**Duke Energy  
Enclosure 2  
Levy Nuclear Plant Units 1 and 2

Request for Exemption Regarding  
Main Control Room Dose

**Duke Energy**  
**Enclosure 3**  
**Levy Nuclear Plant Units 1 and 2**  
**Tier 1 and Tier 2 Licensing Basis Documents –**  
**Proposed Changes (Convenience Copy)**

DCD Figure 9.4.1-1 Sheet 5

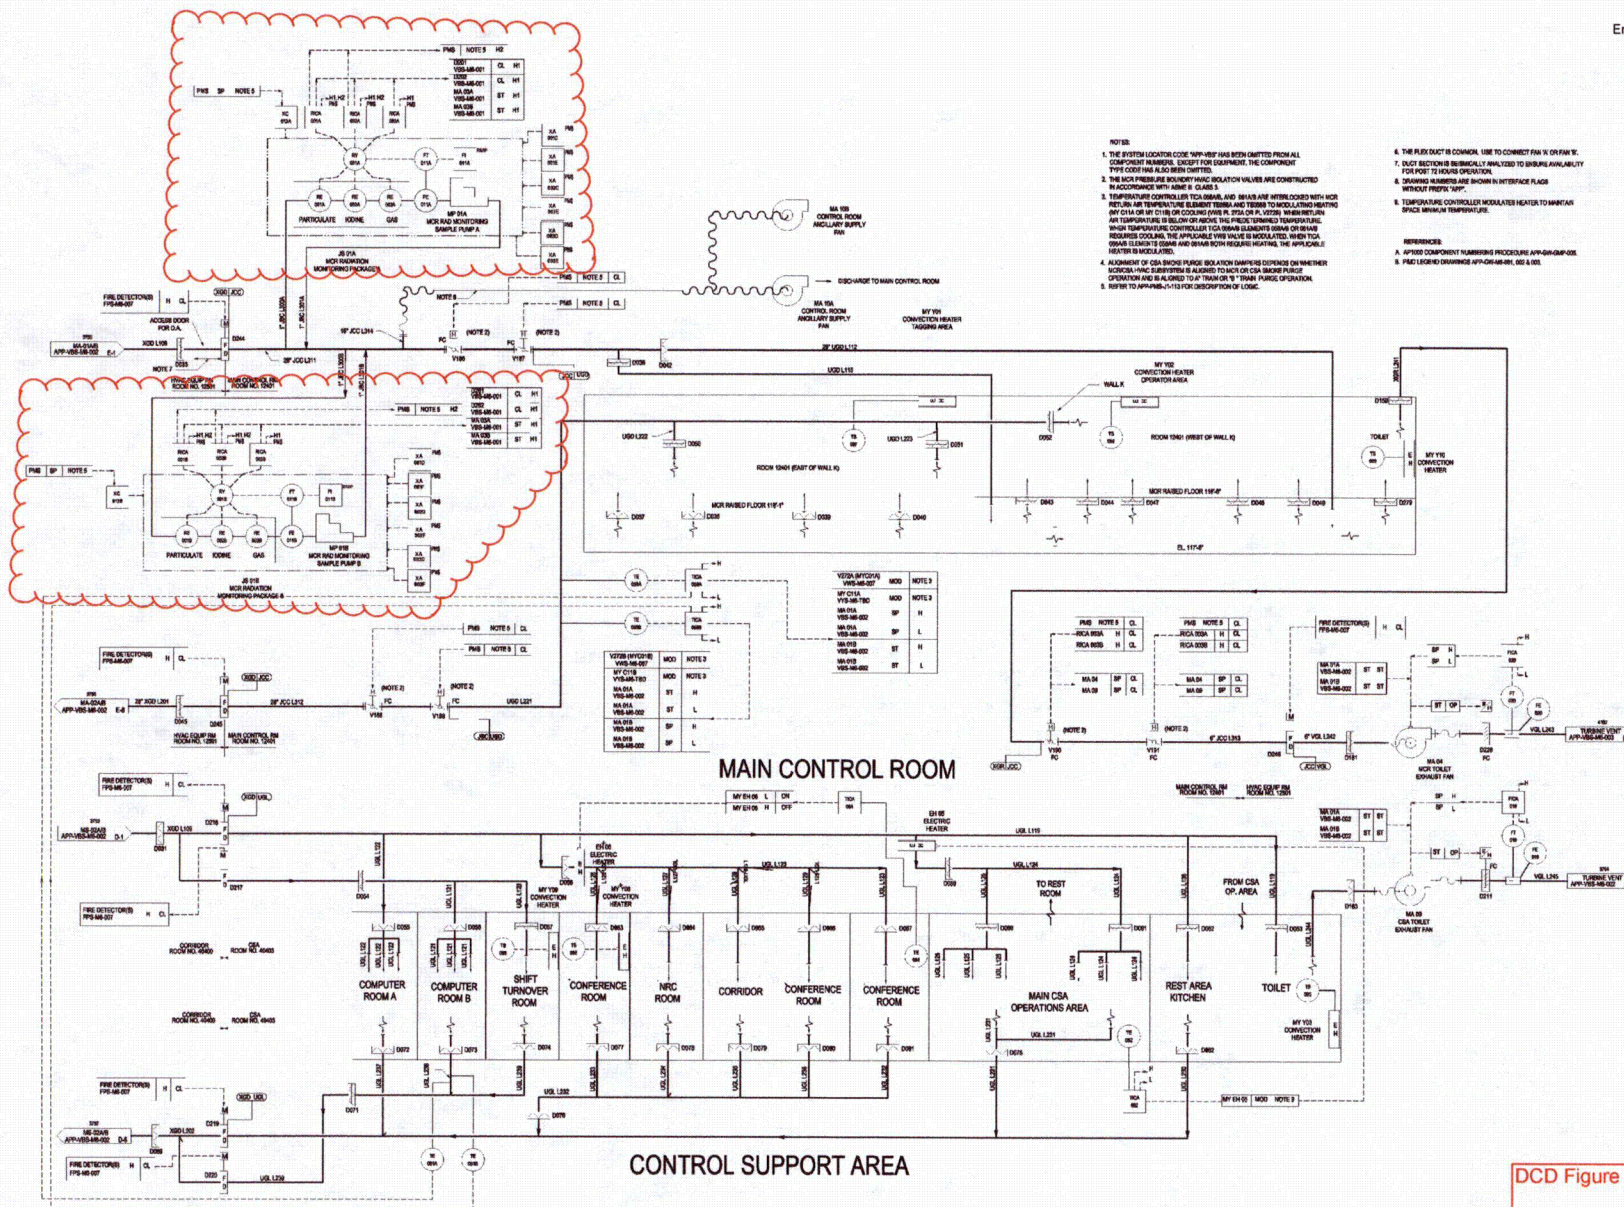
Control actions are taken at two levels of radioactivity as detected in the main control room supply air duct. The first is "~~highHigh-1~~" radioactivity based upon ~~gaseous~~-radioactivity instrumentation (~~gaseous, particulate, or iodine~~). The second is "~~high-highHigh-2~~" radioactivity based upon either particulate or iodine radioactivity instruments.

If "~~high~~High-1" ~~gaseous~~ radioactivity is detected in the main control room supply air duct and the main control room/control support area HVAC subsystem is operable, both supplemental air filtration units automatically start to pressurize the main control room and CSA areas to at least 1/8 inch wg with respect to the surrounding areas and the outside environment using filtered makeup air. The normal outside air makeup duct and the main control room and control support area toilet exhaust duct isolation dampers close. The smoke/purge exhaust isolation dampers close, if open. The main control room/control support area supply air handling unit continues to provide cooling with recirculation air to maintain the main control room passive heat sink below its initial ambient air design temperature and maintains the main control room and CSA areas within their design temperatures. The supplemental air filtration subsystem pressurizes the combined volume of the main control room and control support area concurrently with filtered outside air. A portion of the recirculation air from the main control room and control support area is also filtered for cleanup of airborne radioactivity. The main control room/control support area HVAC equipment and ductwork that form an extension of the main control room/control support area pressure boundary limit the overall infiltration (negative operating pressure) and exfiltration (positive operating pressure) rates to those values shown in Table 9.4.1-1. Based on these values, the system is designed to maintain personnel doses within allowable General Design Criteria (GDC) 19 limits during design basis accidents in both the main control room and the control support area.

If ac power is unavailable for more than 10 minutes or if "~~high~~ ~~high~~High-2h" particulate or iodine radioactivity is detected in the main control room supply air duct, which would lead to exceeding GDC 19 operator dose limits, the protection and safety monitoring system automatically isolates the main control room from the normal main control room/control support area HVAC subsystem by closing the supply, return, and toilet exhaust isolation valves. Main control room habitability is maintained by the main control room emergency habitability system, which is discussed in Section 6.4.
